DRIVEABILITY—HESITATION ON ACCELERATION WHEN COLD—VEHICLES PRODUCED BEFORE 3/5/2001 EQUIPPED WITH 3.0L DURATEC ENGINE ONLY

Article No. 02-1-1

FORD: 2001 ESCAPE

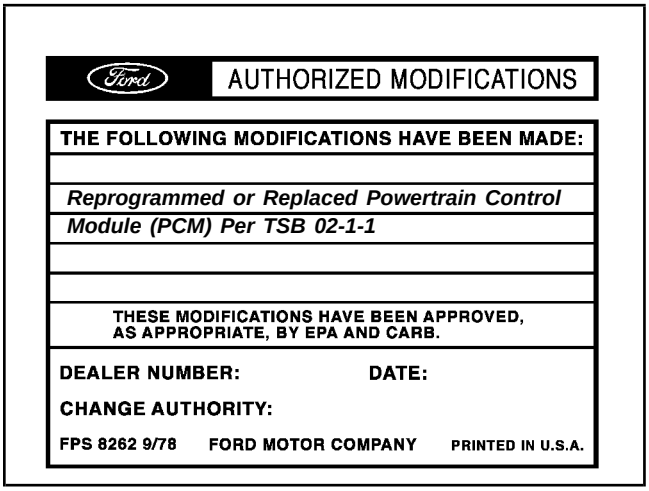
Obtain an Authorized Modifications Decal (STAT 5941-2 - obtainable through the PDC) and list the date, dealer number, and summary of modifications performed. Select a prominent place adjacent to the Vehicle Emission Control Information Decal suitable for installing the Authorized Modifications Decal. Clean the area, install the decal, and cover it with a clear plastic decal shield.
